Central Iowa Developers LC - 5100 NE 38th Avenue

Request from Central Iowa Developers, L.C. (owner) represented by William Kline (officer) to rezone property located at 5100 NE 38 th Avenue			File # ZON2008-00020	
Description of Action	Rezone property from "A-1" Agricultural District to "PUD" Planned Unit Development to allow for development of approximately 35 acres with 1.5 acres designated for commercial development, approximately 15 acres of medium-density residential with a maximum density of 17 units per acre, approximately 10 acres of medium-density residential with a maximum density of 12 units per acre, and approximately 8.5 acres of low/medium-residential with a maximum of 8 units per acre.			
2020 Community Character Plan	Not Designated			
Horizon 2025 Transportation Plan	NE 56 th Street from Jennifer Drive (Pleasant Hill) to 8 th Street SW (Altoona) to widen from 2 lane undivided to 3 lane undivided			
Current Zoning District	"A-1" Agricultural District

PUD CONCEPT PLAN FOR
BROOK RUN NORTH
 DES MOINES, IOWA

Communication from the City Plan and Zoning Commission advising that at their meeting held May 15, 2008, the following action was taken:

PUD CONCEPT PLAN	SHEET 2 OF 2
------------------	--------------

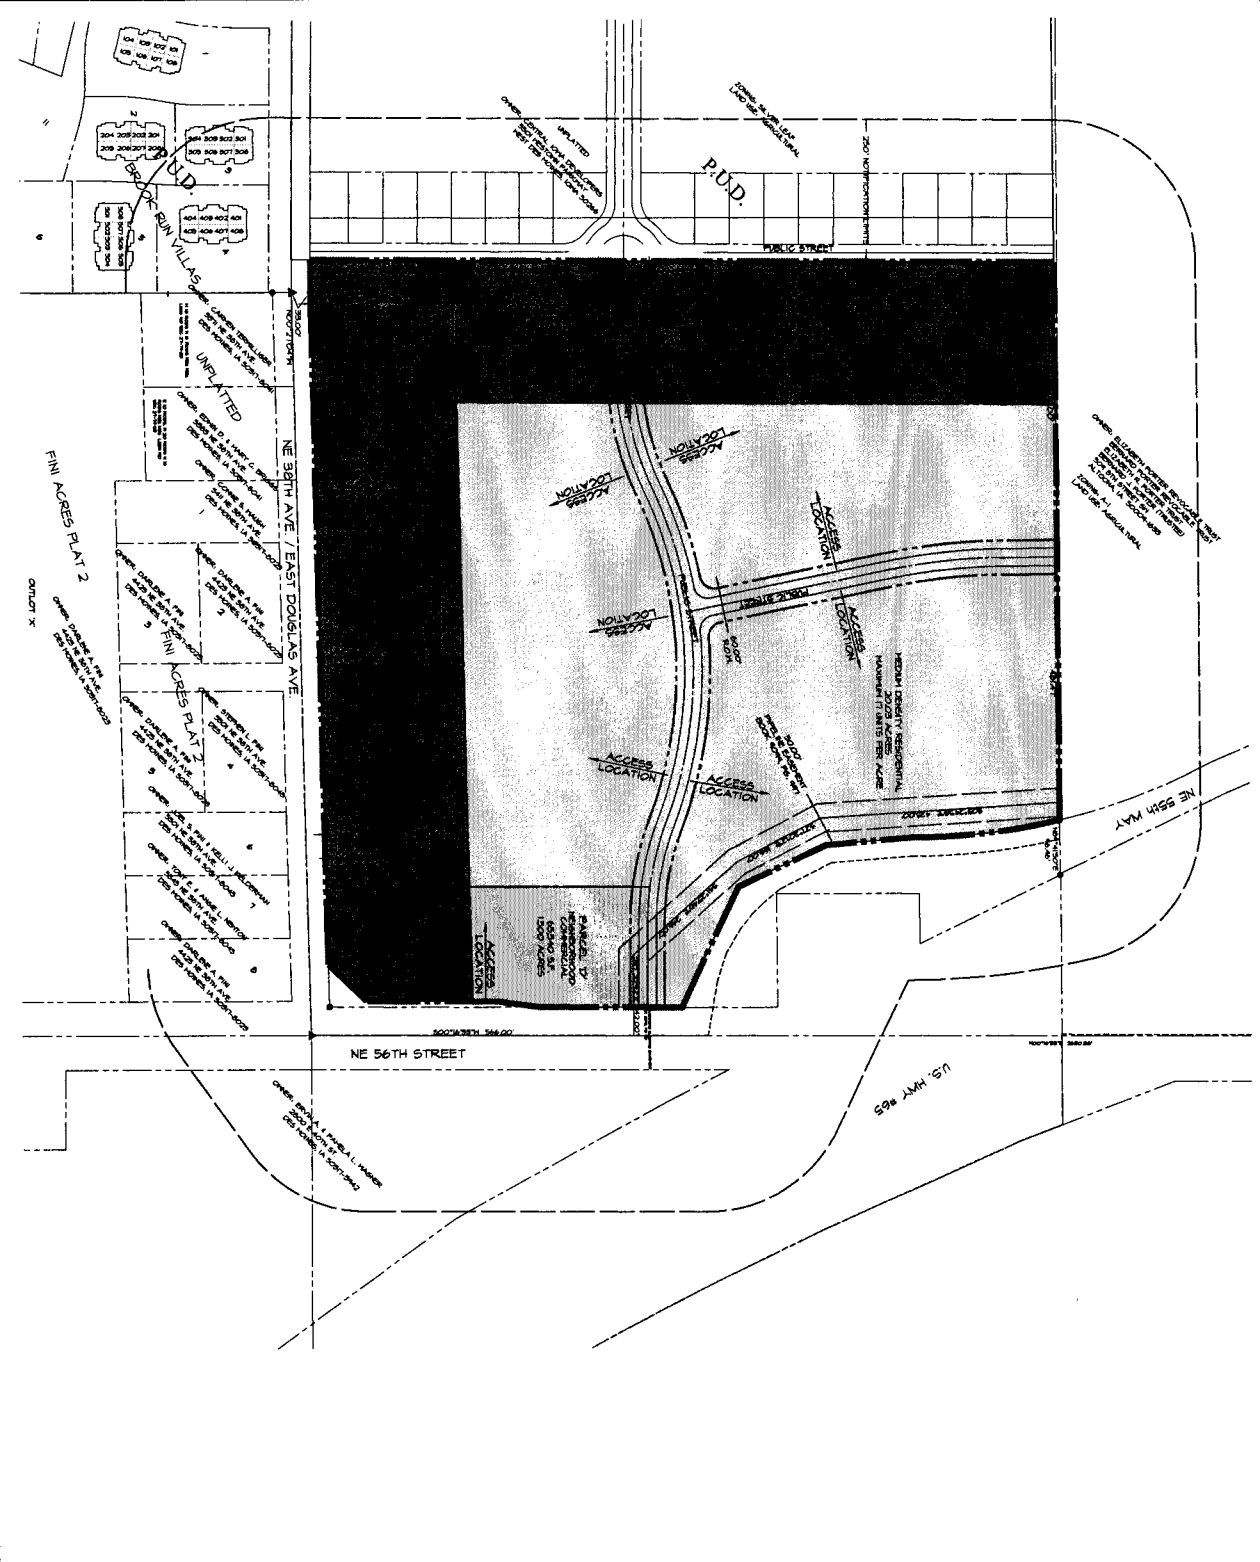
2. Replacement of notes pertaining to the "Low/Medium Density Residential" and "Medium Density Residential" bulk standards and permitted uses with a note that states Density ranges are provided but "the design, building placement and overall density will be determined by future Concept Plan amendments."

3. Provision of a temporary turnaround for emergency apparatus on the north end of the north/south streets.
4. Provision of a trip generation analysis by the developer prior to any preliminary subdivision plat approval. Contribution to necessary improvements of NE 38th Avenue as determined necessary by the analysis.

7. Addition of notes discussing the feasibility of providing sanitary and storm water facilities in the development to the satisfaction of the City Engineer.

8. Identification of approximate location of storm water management facilities to the satisfaction of the City Engineer.
9. Identification of approximate locations of any existing easements and all proposed easements to the satisfaction of the City Engineer.

12. Parcel D be shifted to a location approximately 250' north of the NE 38th Avenue and NE 56th Street intersection;
13. Transition of density from existing and proposed low density residential along the west and south boundaries.

2. **Drainage/Grading:** A PUD concept plan must include a discussion of how storm water management will be handled and identify the approximate location of future storm water management facilities. The submitted Concept Plan does not include this information. Staff recommends that providing this information to the satisfaction of the City Engineer be a condition of approval.

The proposed east/west street is shown intersecting a road identified on the Concept Plan as NE 55th Way approximately 150' west of NE 56th Street. Generally, this is an appropriate location for access to NE 56th Street. However, the City's Traffic and Transportation Division is concerned with the design of the intersection with NE 55th Way and NE 56th Street as shown. The applicant will need to continue to work with the City's Traffic and Transportation Division as plans for the site are refined. This may include consulting with the Iowa Department of Transportation as much of the area to the east of the site is Highway 65 right-of-way. The final alignment of the intersection will be determined as amendments are made to the Concept Plan to allow for the development of the site.

Staff also believes that Parcel A should be identified as Low-Medium Density Residential to provide a proper transition from the Silver Leaf "PUD" to the west. Staff also believes that the southern portion of Parcel C should be identified as Low-Medium Density Residential.

Dann Flaherty: Asked about the corner of Douglas and NE 56th Street not being able to support the traffic for a commercial use. Asked about moving that parcel to the north and away from the intersection.

Tim Urban: Asked how the multiple points of access to the east would be resolved. Noted the intersection there would be hard to manage.

Dann Flaherty: Asked about the C-1 parcel at the southeast corner. Suggested there be no direct commercial access from Douglas and 56th Street to alleviate traffic concerns or move the Commercial to the north, which would offer the opportunity to access the commercial areas from the new street. Moving to the west would put the commercial development across from Brook Run, which would have traffic coming from there.
